In re: Denbury Green Pipeline-North Dakota, LLC
12-Inch Cedar Hills Pipeline Project
Slope and Bowman Counties
Case No. PU-19-294
Our File No. 025331-000058

Certification and documentation for route adjustment under section N.D.C.C.49-22.1-15(3)&(1)

Subject: CHSU Lateral CO2 Pipeline Project
Bowman County, North Dakota
Route Adjustments and Proposed Additions to the Designated Corridor

Figure 1. Map with paleontological resource analysis areas for Reroute 1 and ATWs 1 through 4.

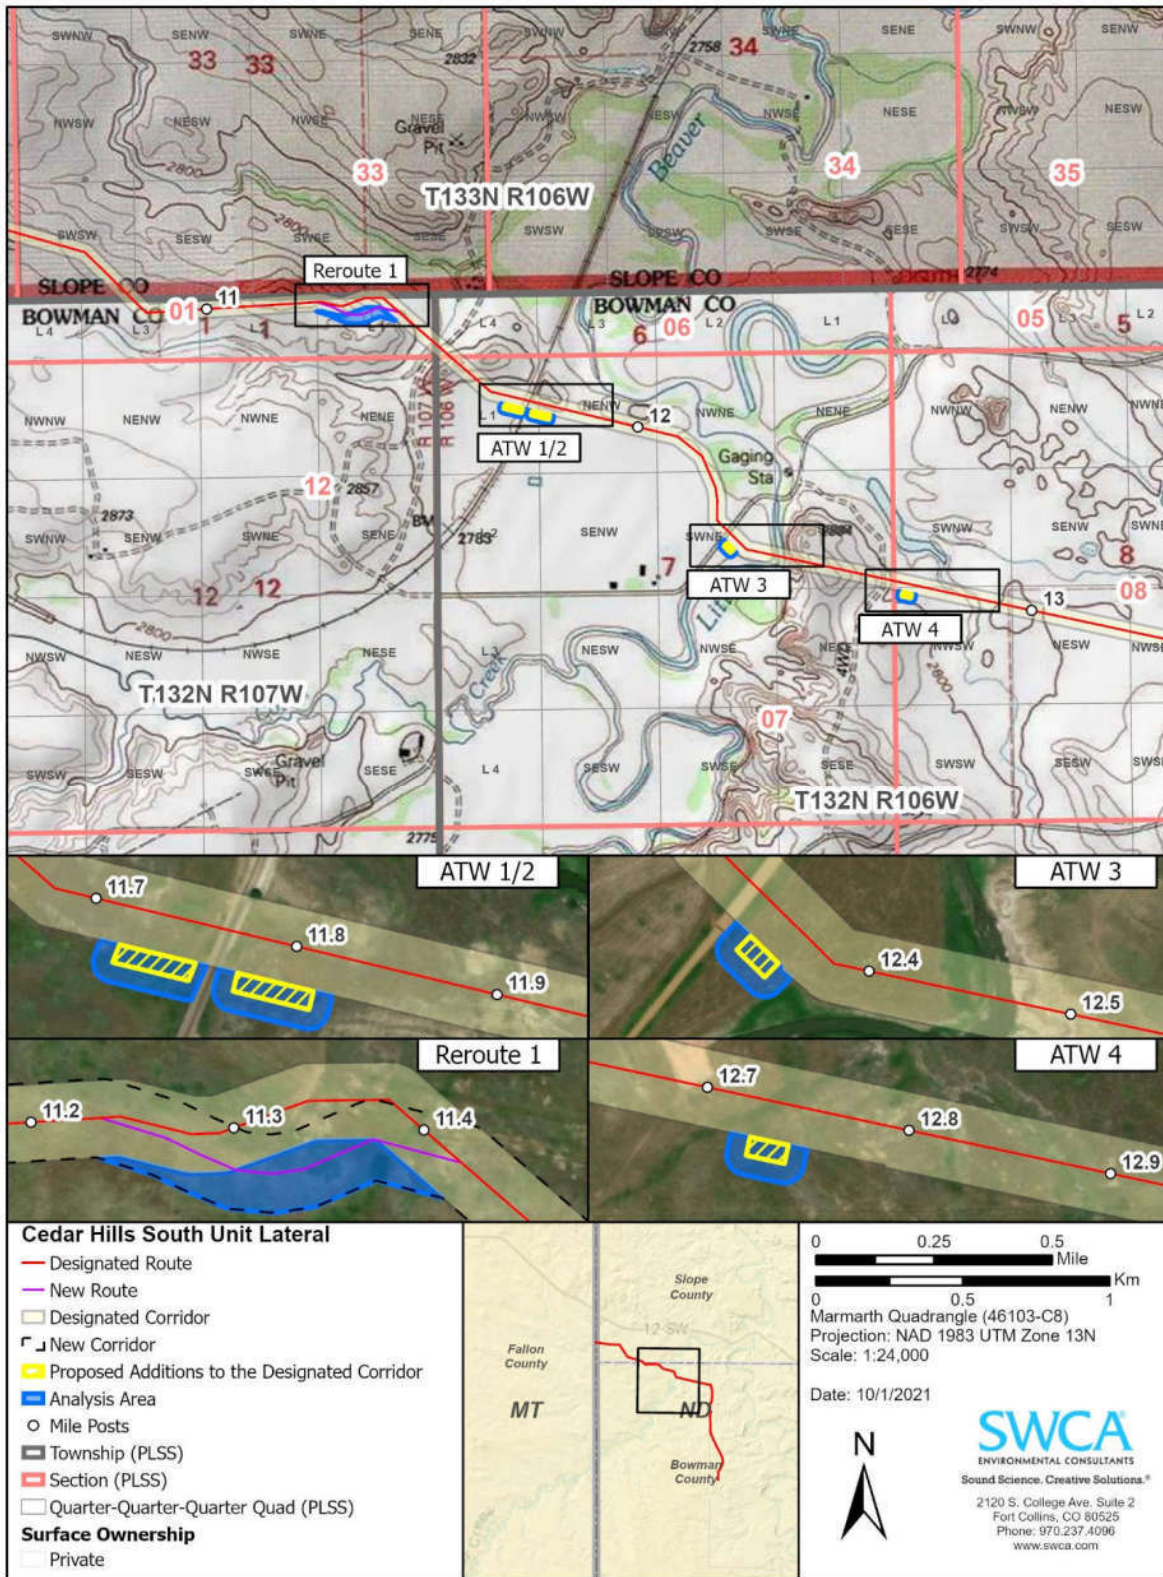
- Reroute 1 (# CHSU-CL-003), from milepost (MP) 11.2 through MP 11.4, is in a portion of the project that was previously cleared for paleontological resources through a review of aerial imagery due to the lack of bedrock exposures. The route adjustment to the south is completely within the property of Hadley Brothers LLP and the length of segment is 0.18 miles. Terrian, and the potential for bedrock exposures of mapped Fox Hills Formation, is the same as observed in the previously analyzed area along this portion of the pipeline. The area is mostly vegetated, sloping, with some cobble-armored slopes and ridges near MP 11.3, possibly representative of unmapped Quaternary or Tertiary gravels. No pedestrian survey was conducted. Exposed paleontological resources are not expected within the route adjustment.

- ATW 1 and ATW 2, near MP 11.7 and MP 11.8, respectfully, are in a portion of the project that was previously cleared for paleontological resources through a review of aerial imagery due to lack of exposures of the mapped Pierre Shale Formation. The area is mostly vegetated with minor weathered areas (or blow outs) within the ATW 2 analysis area. Exposed paleontological resources are not expected within the ATWs.

- ATW 3, northwest of MP 12.4, is in a portion of the project that was previously cleared for paleontological resources through an aerial image review due to lack of bedrock exposures. In addition, while conducting initial pedestrian surveys nearby, a paleontologist walked through the area to access the next survey area (i.e., bedrock exposure). The area is vegetated with no exposures of the mapped Fox Hills Formation. Exposed paleontological resources are not expected within the ATW.

Figure 2. Map with paleontological resource analysis area for Reroute 2.

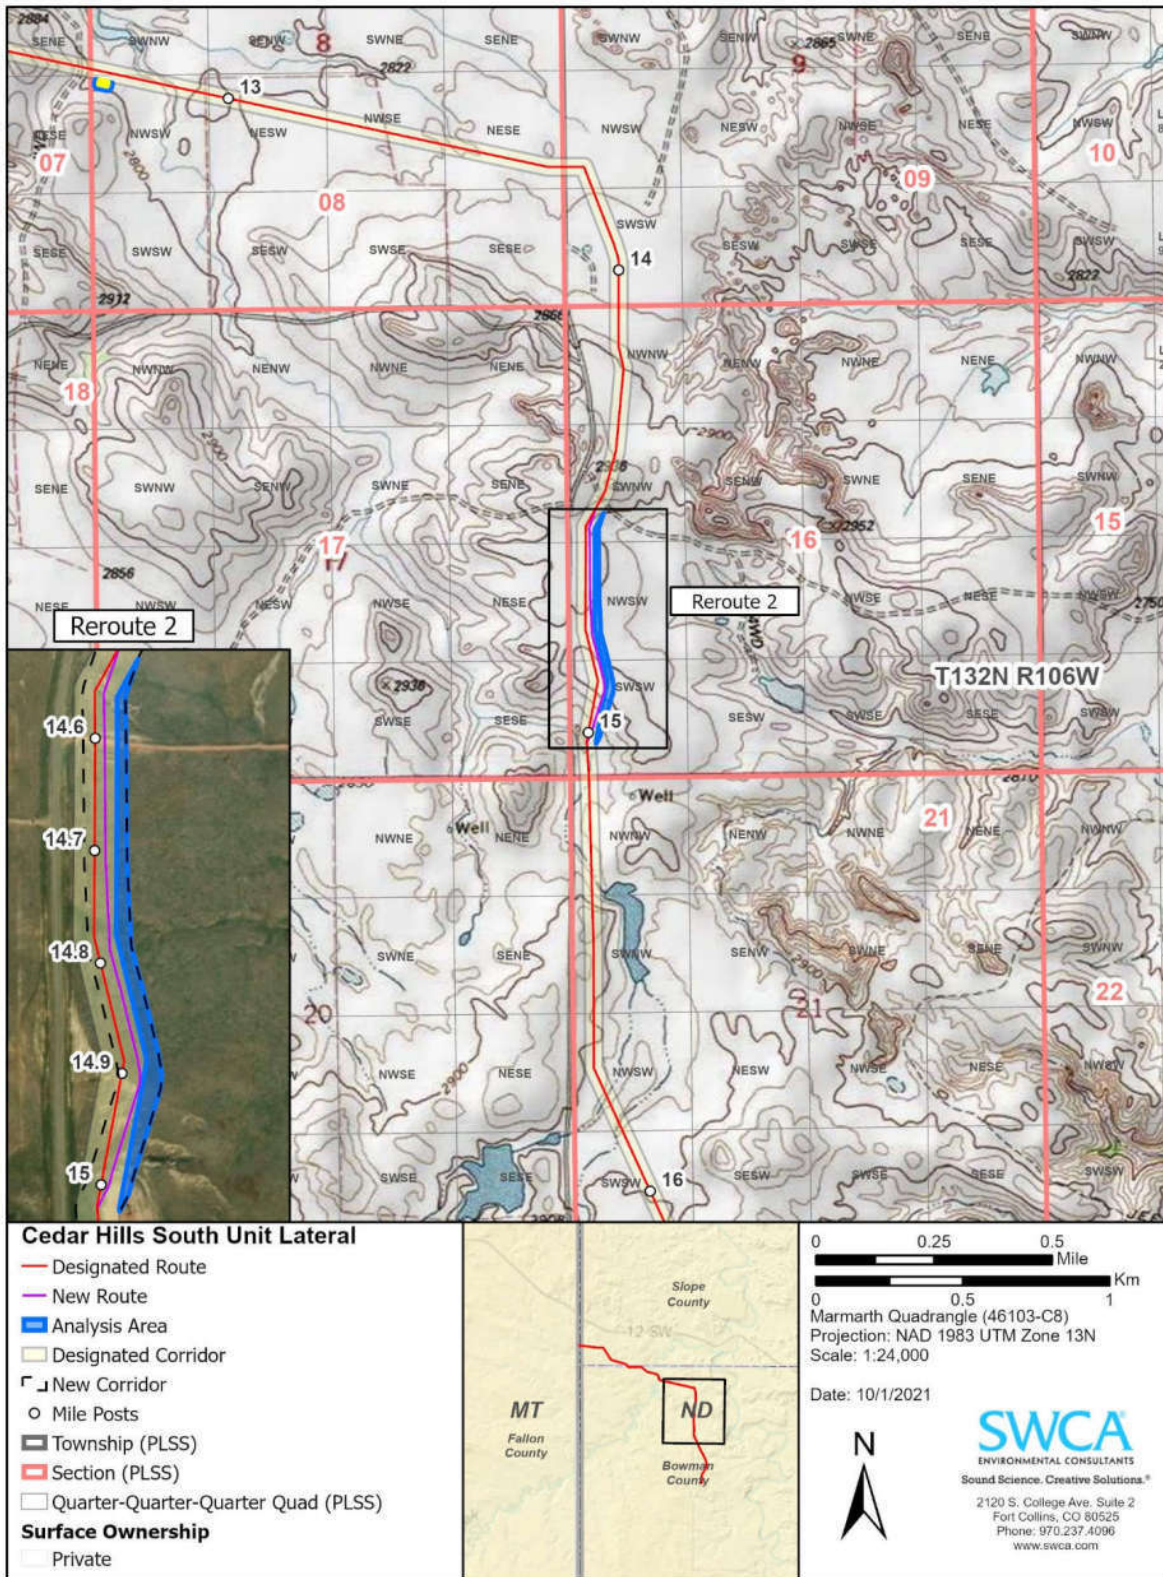
- Reroute 2 (# CHSU-CL-004), from milepost MP 14.5 through MP 15, is adjacent to a portion of the project analysis area that was previously surveyed for paleontological resources. No paleontological resources were observed during initial paleontological project surveys near this reroute (Knauss et al., 2019) and no pedestrian survey was conducted for this reroute. The route adjustment is to the east within the Fischer property and the length of the segment is 0.5 miles. While there is a sandstone exposure, possibly of the mapped Hell Creek Formation within the analysis area at MP 14.9, the route shift (e.g., no more than 30 feet east) keeps most of the proposed disturbance area within the previously surveyed area and/or mostly vegetated areas. In addition, as is typical with standard paleontological survey methodology, pedestrian surveys of small exposures of this type would be unlikely to detect any significant paleontological resource. Exposed paleontological resources are not expected within the route adjustment.

Figure 3. Map with paleontological resource analysis areas for ATW 5.

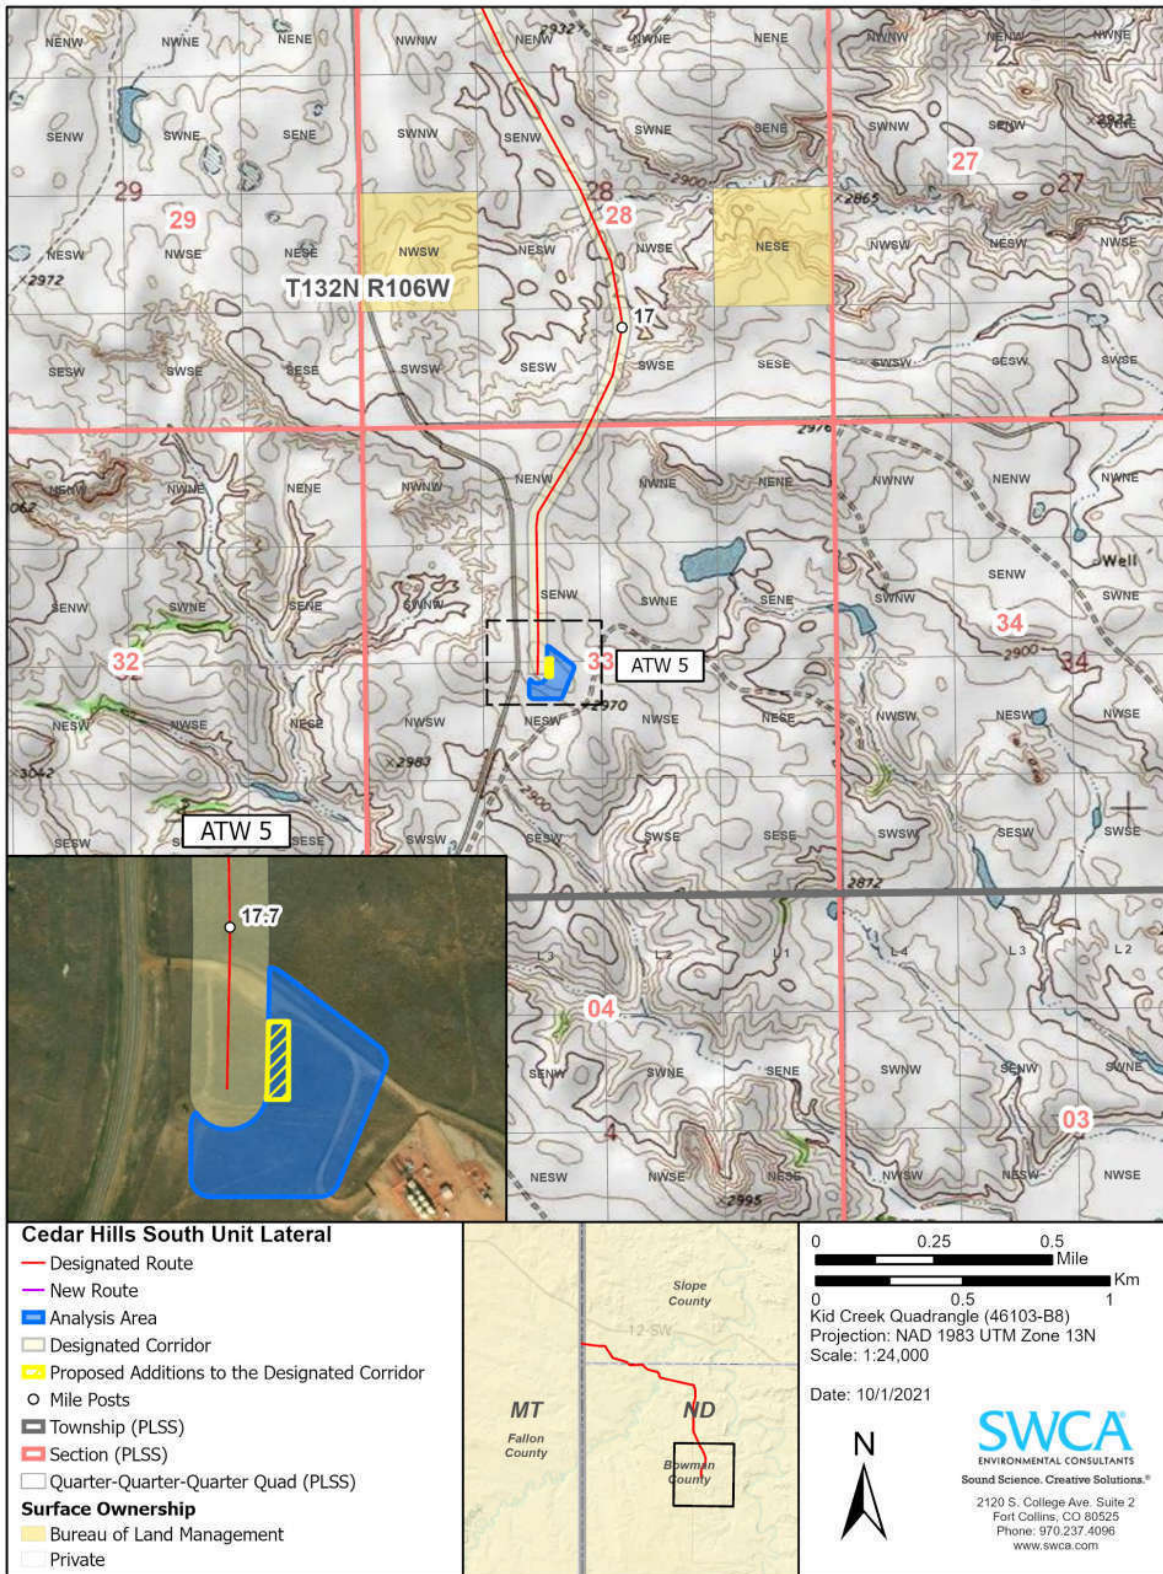
- ATW 5, south of MP 17.7, is in a portion of the project that was previously cleared through an aerial image review and a visual review conducted during pedestrian paleontological surveys in the area due to lack of bedrock exposures. The area is vegetated with no exposures of the mapped Hell Creek Formation. Exposed paleontological resources are not expected within the ATW.

Exhibit "A"
CH.ND.BO.0011.000

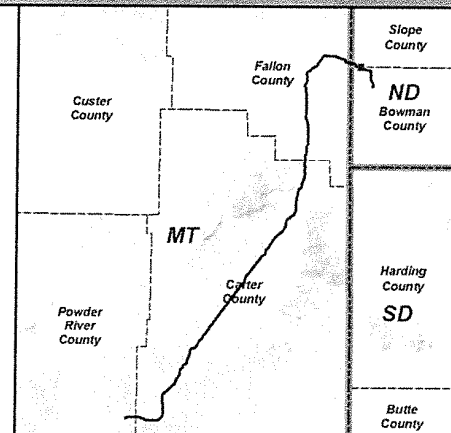
WHEREAS, the Agreement will need to be amended to show these changes to the Easement Area (as defined in the Agreement), the Exhibit “A”, and the temporary work spaces along the pipeline route; and

WHEREAS, this Amendment is intended clarify the changes to the Easement Area and the temporary work spaces, to confirm Grantor’s approval of these changes, and to amend the Agreement to specifically include the new portions of the Easement Area, the temporary work spaces, and the Exhibit “A”.

CH.ND.BO.0019.000

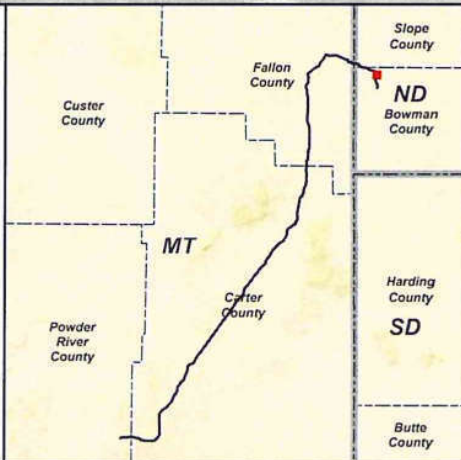
WHEREAS, the Agreement will need to be amended to show these changes to the Easement Area (as defined in the Agreement), the Exhibit “A”, and the temporary work spaces along the pipeline route; and

WHEREAS, this Second Amendment is intended clarify the changes to the Easement Area and the temporary work spaces, to confirm Grantor’s approval of these changes, and to amend the Agreement to specifically include the new portions of the Easement Area, the temporary work spaces, and the Exhibit “A”.
